July 26, 2020 RESPONSES TO QUESTIONS IN JULY 23th and 24th EMAILS

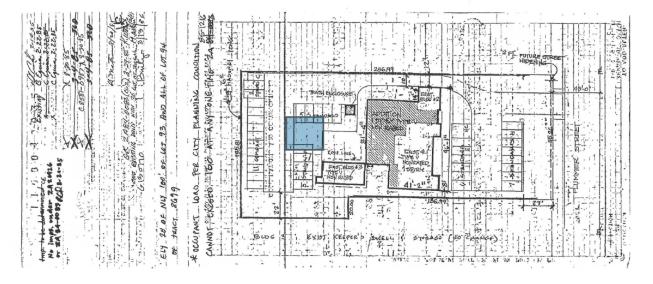
What was the previous land use classification that required 38 parking spaces? Confirm that you are requesting to be reclassified as an office and philanthropic institution. I'm confused with the calculation you provided because it would only require 14 parking spaces. Provide previous calculations required 38 parking spaces and confirm that the new parking requirement calculation is only based off of the addition and not the overall size of the new building.

Response: Case No. ZA 85-1216-CUZ, page 8 it states, "An additional 14 parking spaces will be provided for the addition thereby resulting in a parking area accommodating a total of 38 vehicles exceeding a <u>ratio of one parking space for every five occupants</u>." (Underline added for emphasis)

There is no request to change the use classification. If you wish, it is appropriate to use "educational institution" cited Section 12.21-C,3(b).

As stated in the submitted Project Analysis and Justifications:

6. That 38 on-site parking spaces shall be maintained on the site

Justification: Condition No. 6 should be updated as deemed necessary by the Zoning Administrator. In Case No. ZA 85-1216-CUZ, the Zoning Administrator imposed parking based on occupancy resulting in 38 required parking spaces. The current parking regulation is based on a ratio of one stall per 500 square feet. This applied to the Project requires two additional parking stalls. When applied to the building total square feet (i.e., 6,994.8), the ratio results in 14 parking spaces.

The <u>Project intends to continue providing 38 parking spaces</u>, as required in Case No. ZA 85-1216-CUZ, and will add one parking stall and eight (8) bicycle parking (2 long term and 6 short term). (Underline added for emphasis)

Prior Building Permit

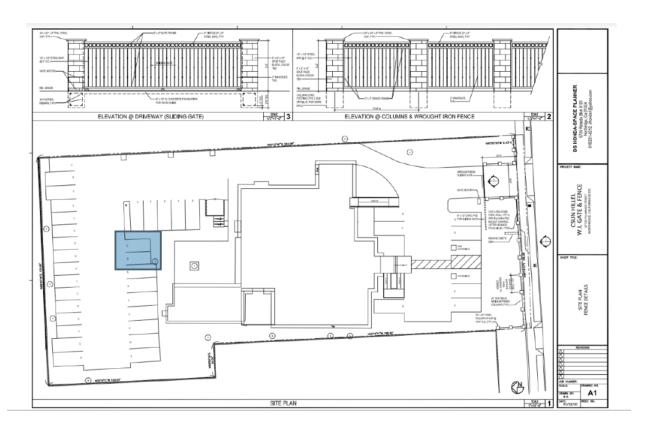
Also, I don't see a proposed site plan with the proposed (2) parking spaces or fence. Will the parking lot be restriped? If so, please include in the new site plan. Is the new fence beyond the front yard setback?

Response: You can see from a prior building permit that the area in blue does not have parking spaces. No restriping will occur. Rather it will be new construction shown on the building plans submitted to Department of Building and Safety. The two additional parking spaces are shown in the second diagram in the blue area. I do not believe a new site plan is warranted to merely show the two additional spaces especially since the use is significantly over parked. It would be another matter, if the additional parking spaces were required by code.
